ARCHITECT'S SUPPLEMENTAL INSTRUCTIONS

PROJECT:	The Reserves at Magnolia New Apartment Complex Denton, TX	Report No.	One (1)
OWNER:	Overland Property Group Dan Maximuk 234 N. Santa Fe Ave, Suite A Salina, KS 67401	Date	Oct. 22, 2024
CONTRACTOR:	Snyder Construction Group 4820 N. Town Centre Dr. Ozark, MO 65721	Architect's Proj No.	21-3205
		Contract For:	General Construction Mechanical, Electrical

Please Note: Drawings and Specification Edits associated with this ASI are dated as **7-17-2024**. This date above is the date this ASI was issued.

A6.2

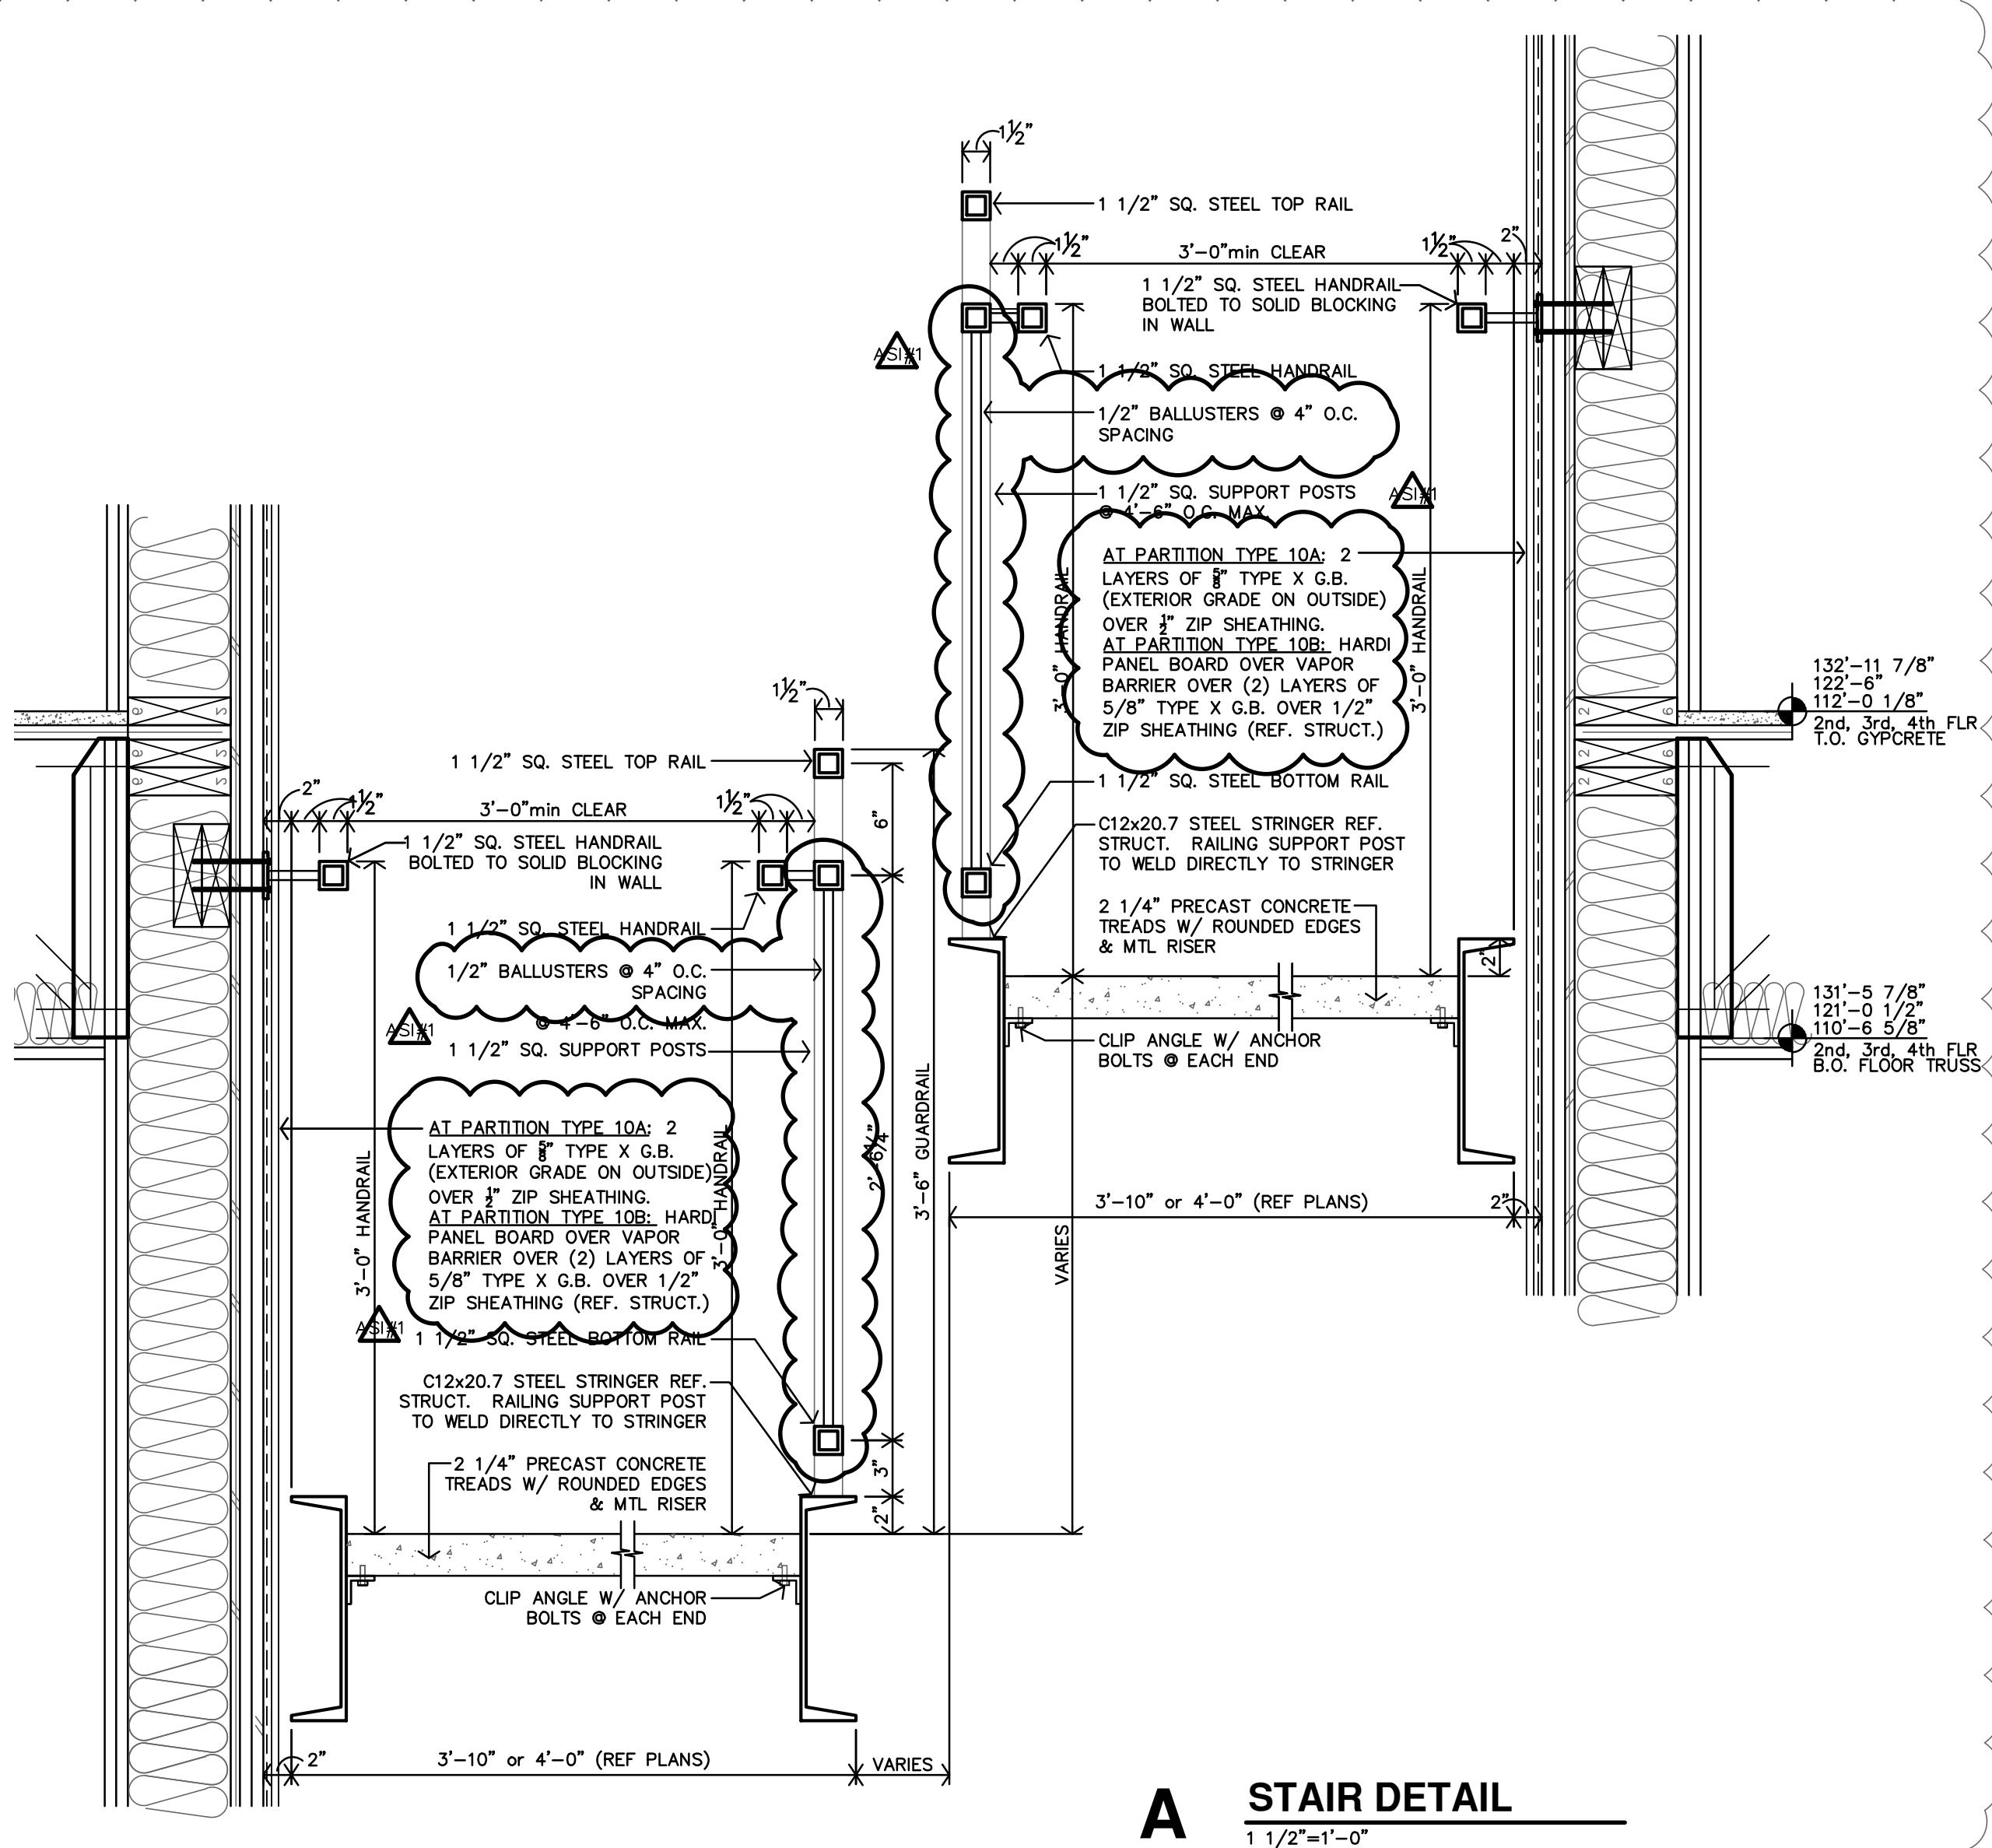
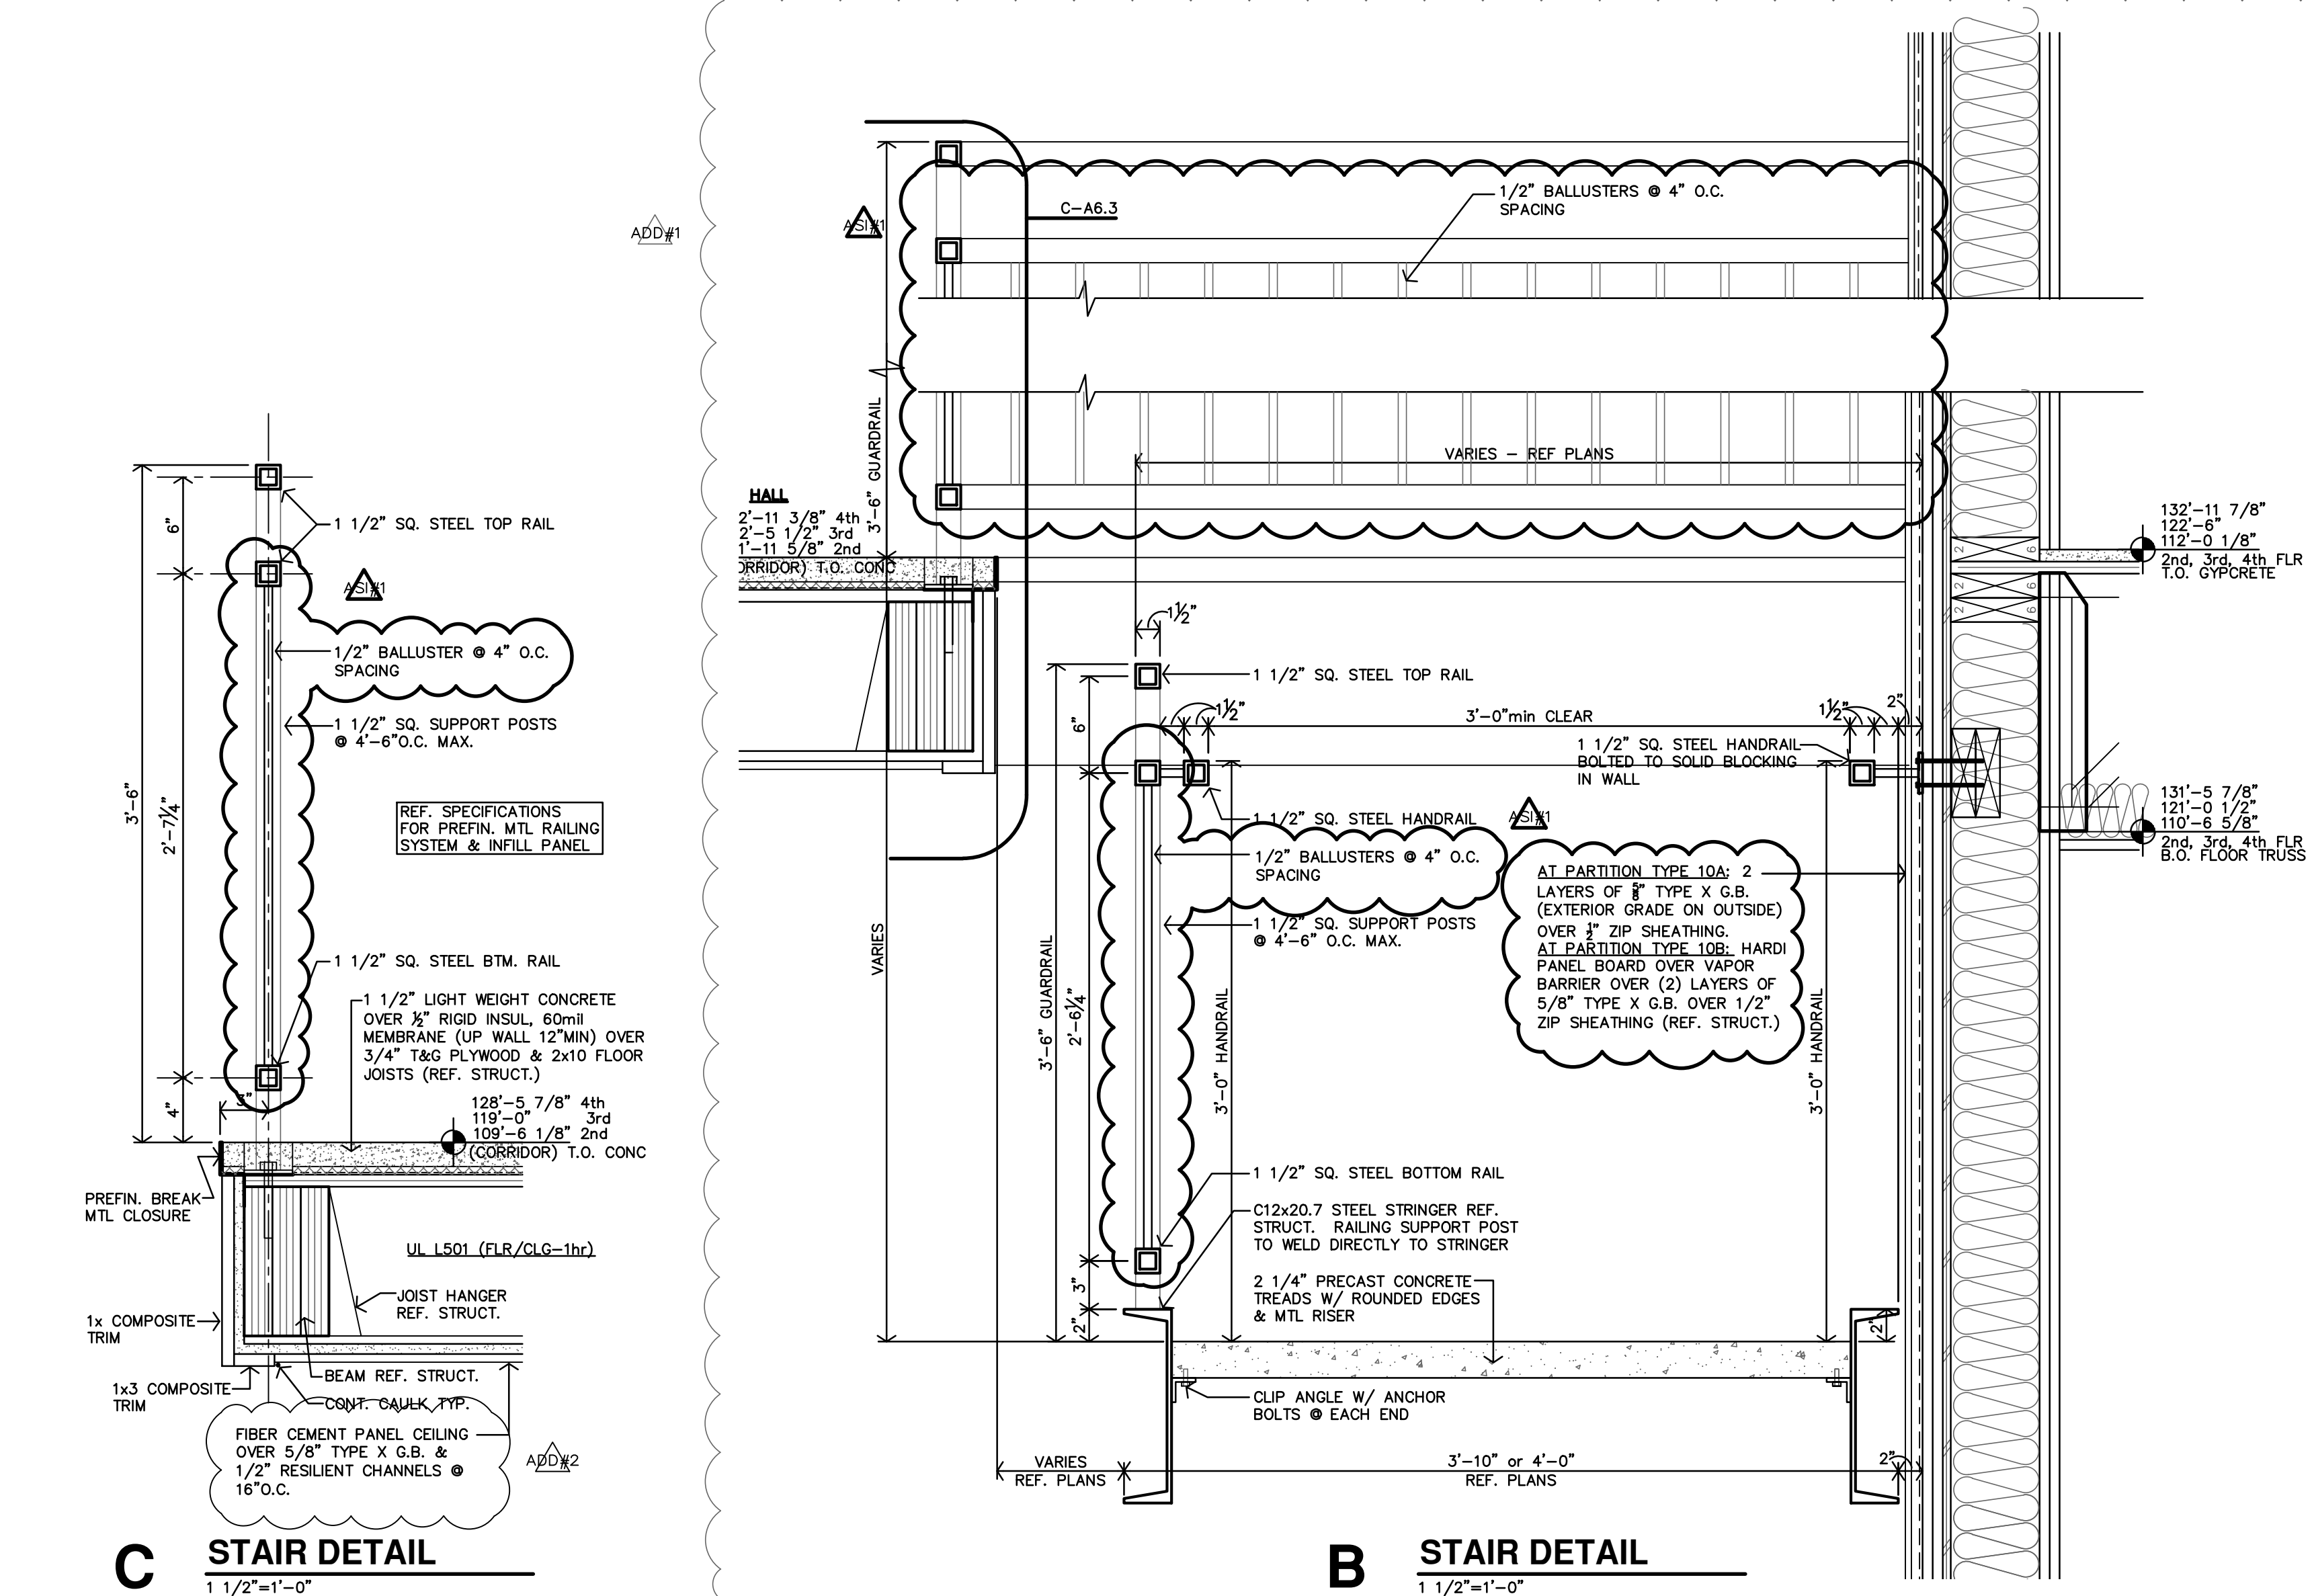
- 7) Utilize standard vertical pickets at the metal stair/landing handrails/guardrail systems in lieu of the custom metal panel railings. (VE Item #10). Reference revised details on Sheets A6.2 & A6.3.

- 17) Omit Security Gate and Doors #114, #116, #121 and #122. (VE item #22). Reference revised plans and details on Sheets A2.1, A3.1, A3.2, A6.1, A6.2 and A10.2.
